Storah Architecture have submitted a Non-Material Amendment application (25/00852/ANM) and Variation of Conditions application (25/00851/VRCON) in relation to the previous Planning approval and Listed Building Consent for Norwich Mill (19/00041/FUL and 19/00042/LBC). This document addresses points raised in the determination of those two applications.

2 List of Changes

Supporting Statement: Norwich Mill, Norwich Street, Rochdale

Roof and Wall Material Choice

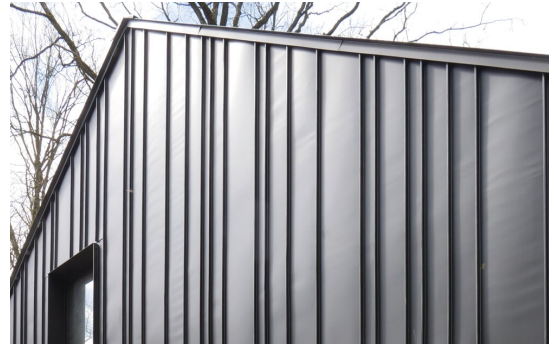
The proposed wall material choice is Kingspan Quadcore KS1000RW LEC Wall panels. This varies from the previous specification of Standing Seam VMZinc Pre-patinated cladding.

The proposed wall material has been selected due to its similar aesthetic to 'Standing Seam VMZinc Pre-patinated cladding' whilst being more cost-effective, improving project viability.

It is proposed to use Kingspan Quadcore KS1000RW wall panels in place of the previously specified VMZinc cladding. This amendment has been driven by several factors:

- Integrated panels offer faster installation, improving the construction programme and reducing disruption and allowing faster completion of a secure, weathertight building envelope.
- Kingspan's QuadCore insulation has one of the highest R-values and provides improved warranted thermal performance, with lifecycle carbon and energy cost savings.
- The significantly higher cost of the VMZinc material makes the approved scheme financially unviable for the applicant.
